Precision Analog Microcontroller ARM Cortex M3, with 12-bit ADC & RF

Anomaly List

ADuCRF101

Second samples of ADuCRF101 are slightly different to the final product and this document describes the differences between second and final silicon. It also includes the known bugs, anomalies, and workarounds for the ADuCRF101 precision analog microcontroller.

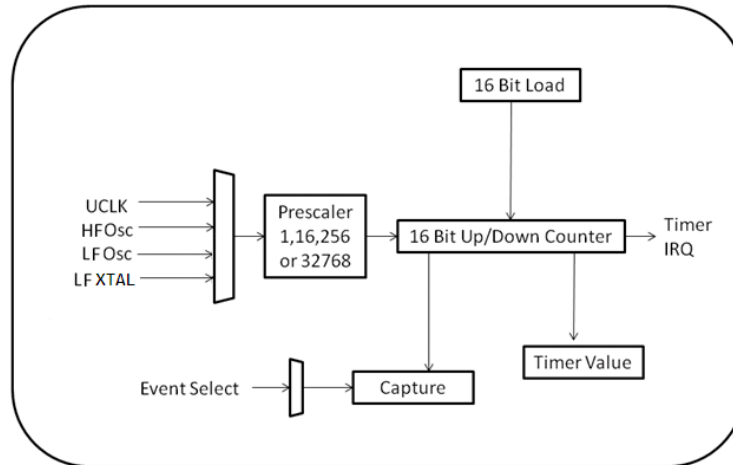
Issue : On second silicon the General Purpose Timer clock sources are slightly different.
Second Silicon: General Purpose Timer Block Diagram:
